Addendum 2 for RFB927940-01

Project Name: WRC Decentralization Phase 4 & Fire Alarm Phase 3 Bid Issuance #1
DAS RFB #: 927940-01
DAS Project #: 9279.40
Date: 05/15/2025

F2 BOILER VENT TERMINATION SECTION VIEW
1/4" = 1'-0" 0 6'

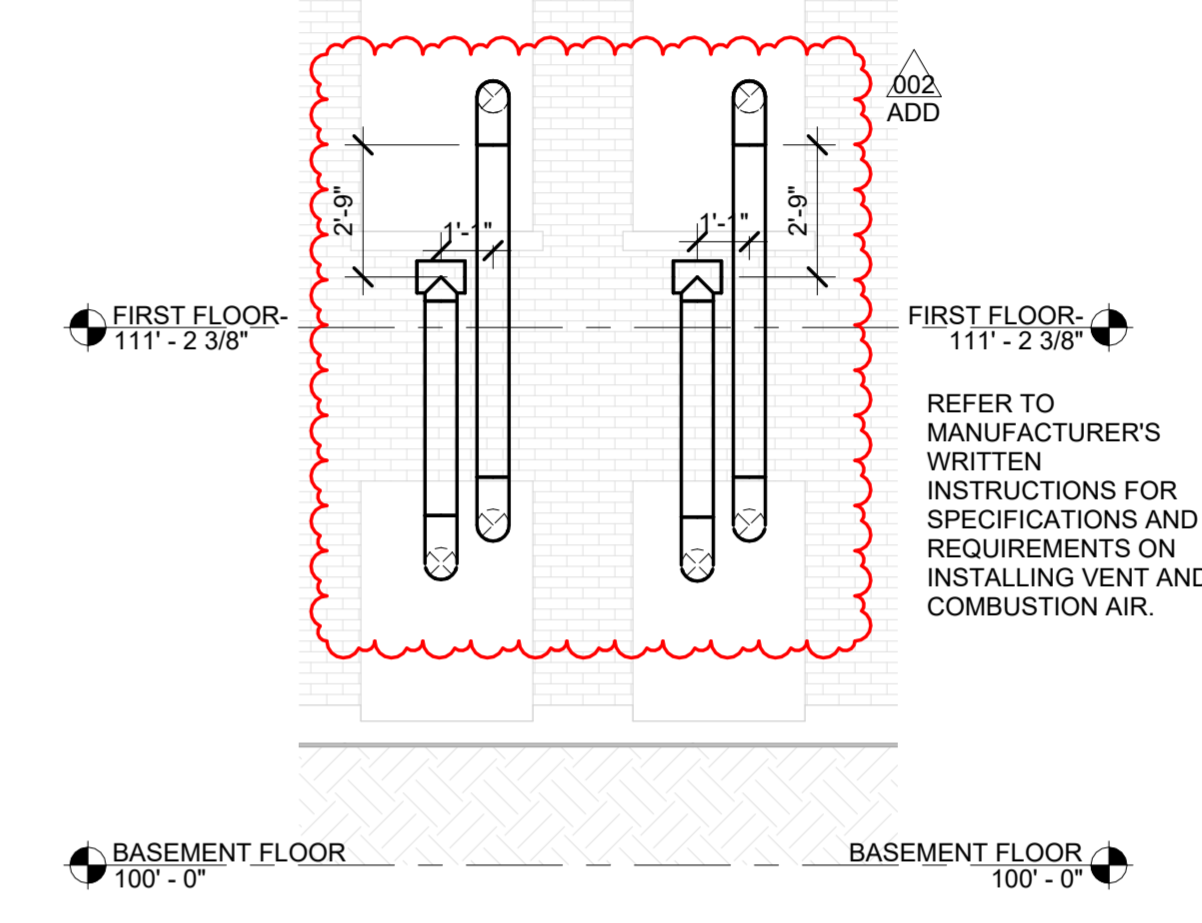
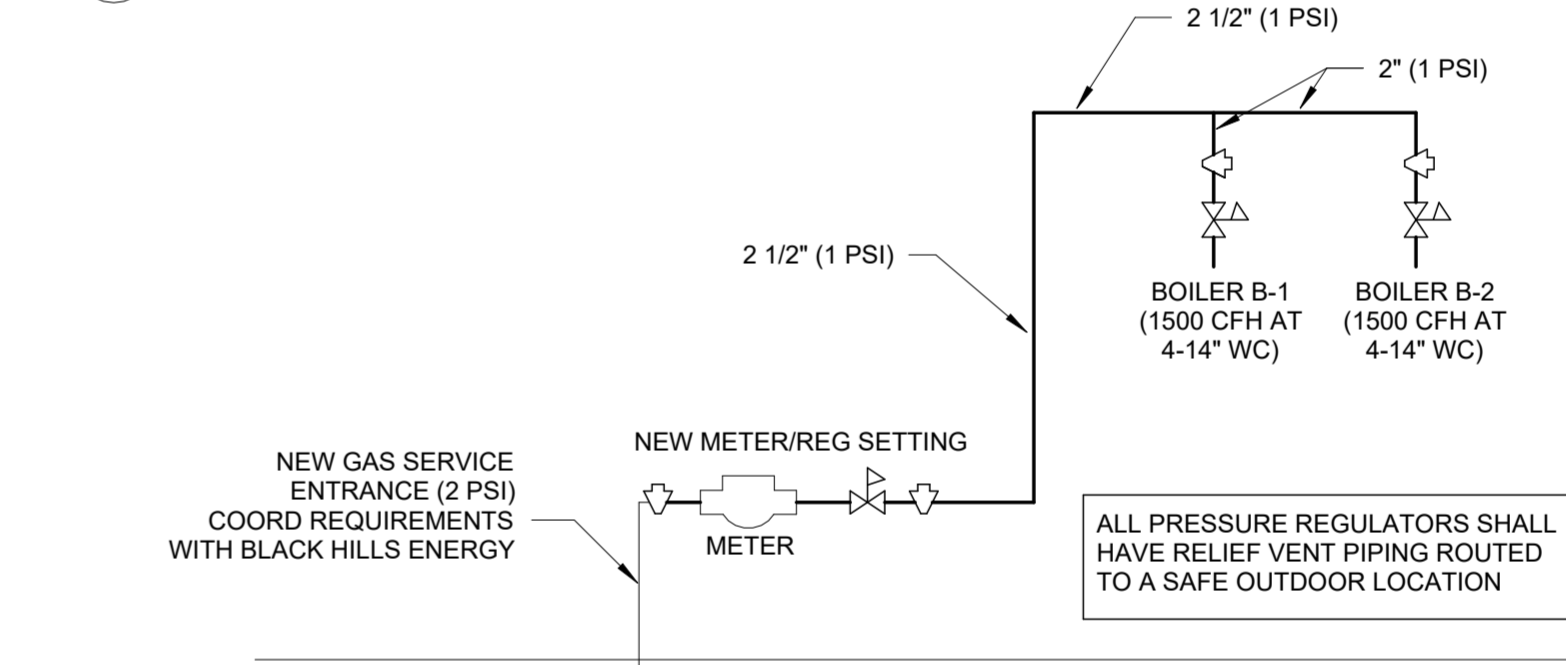
- **16-M400 – ENLARGED MECHANICAL PLANS AND SCHEMATICS**
 - **REVISE** Boiler Flue and Vent routing.
- **16-M600 - MECHANICAL SCHEDULES**
 - **REPLACE** sheet in its entirety.
